**NOTICE OF DECISION TO CONSENT TO CHANGE TO PROPOSAL DURING
ASSESSMENT**

Ravensthorpe Gold Revised Project
Assessment No. 2117

CONSENT TO CHANGE PROPOSAL DURING ASSESSMENT

Proposal: Ravensthorpe Gold Revised Project

Figure 1 – Development envelope of original and changed proposal

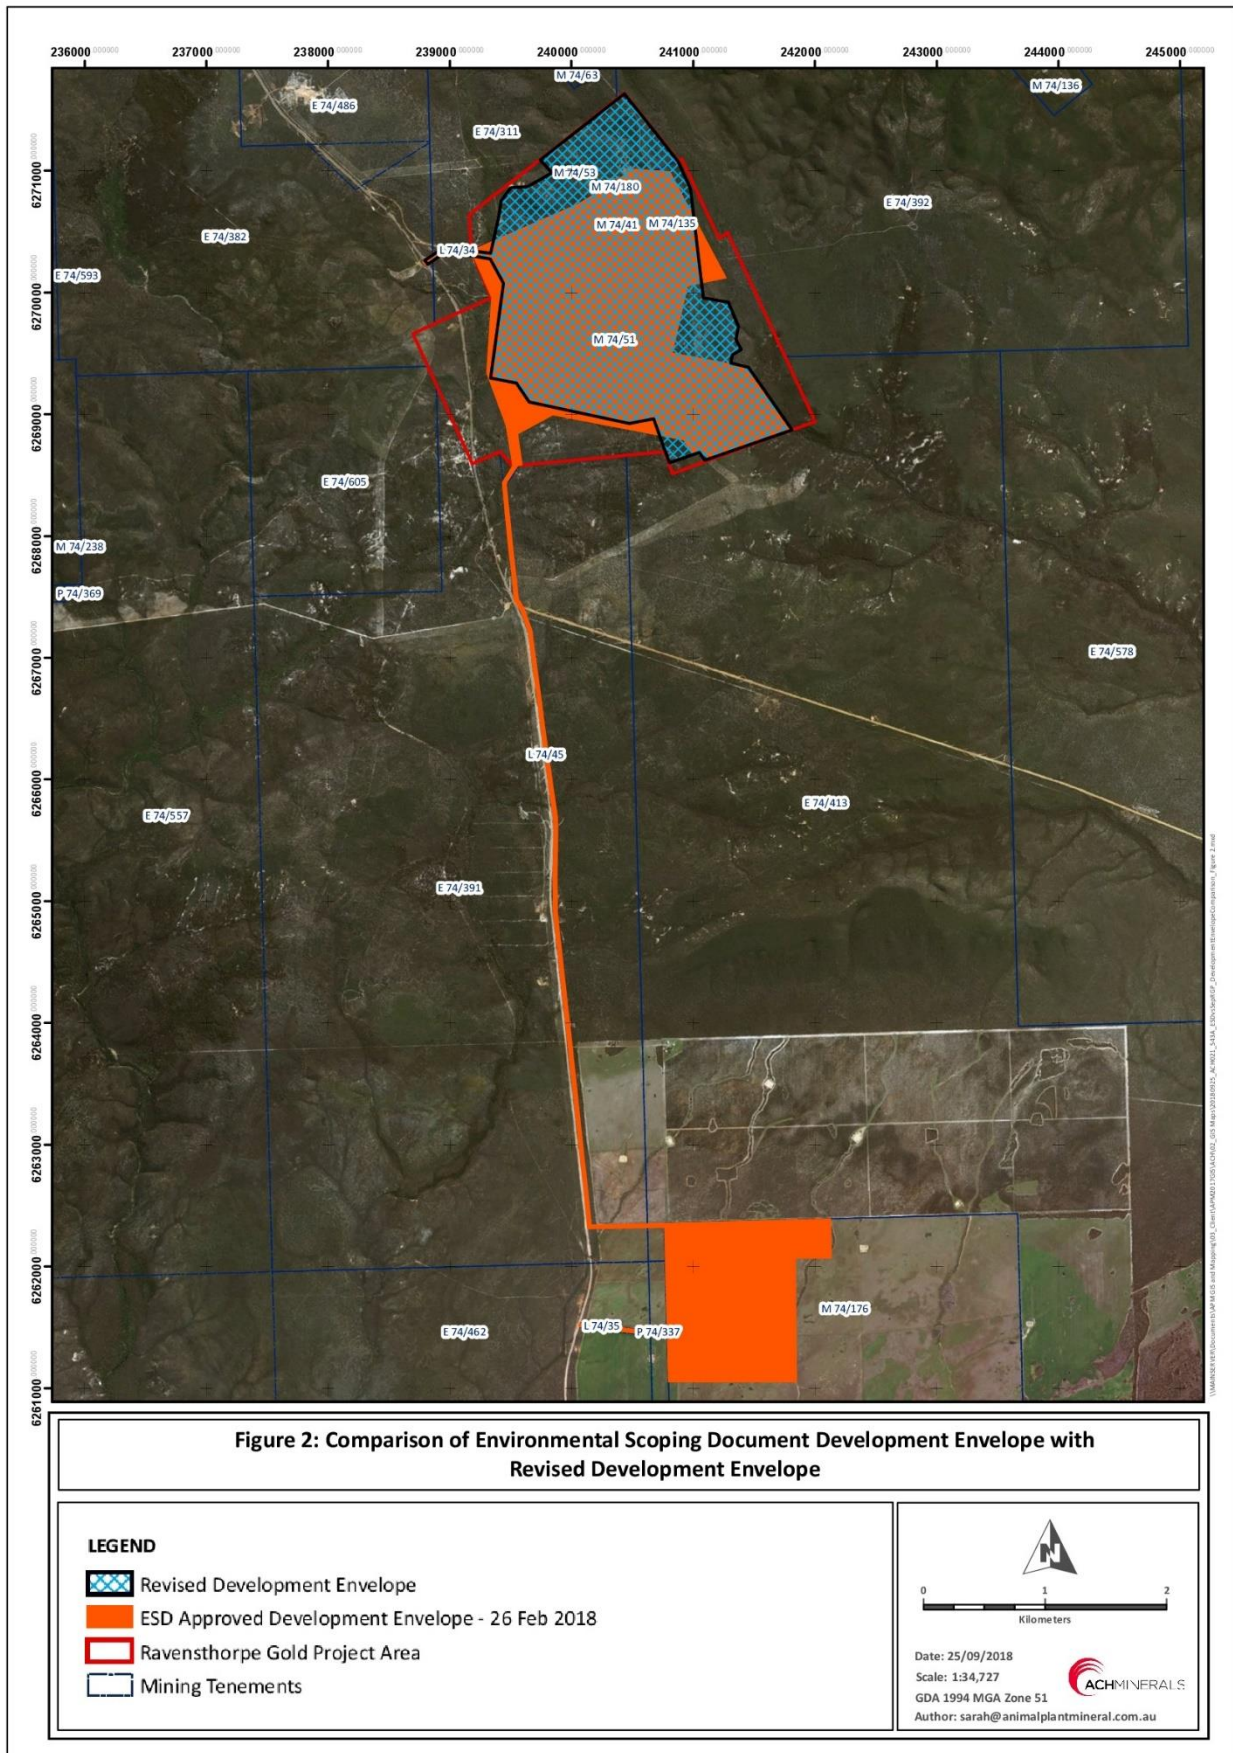
- *decrease of the development envelope from 512 hectares (ha) to 428.4 ha at the Kundip mine site;*
- *increase of the disturbance footprint from 197 ha to 244.7 ha at the Kundip mine site;*
- *removal of the development envelope (149 ha) and disturbance footprint (45.2 ha) at the Myamba mine site;*
- *increase of clearing for the tailing storage facility by 5.2ha and volume by 0.5 million cubic metres; and*
- *correction of groundwater abstraction (error) and increase to 0.8 GL per annum.*

The revised development envelope is shown in Figure 1, and revised disturbance footprint is shown in Figure 2 attached.

The proponent advised that it no longer intends on pursuing development of the Myamba Mine Site and water corridor pipeline (Figure 1). The proposed changes are to remove those areas from the development envelope and expand the Kundip Mine Site to accommodate the following:
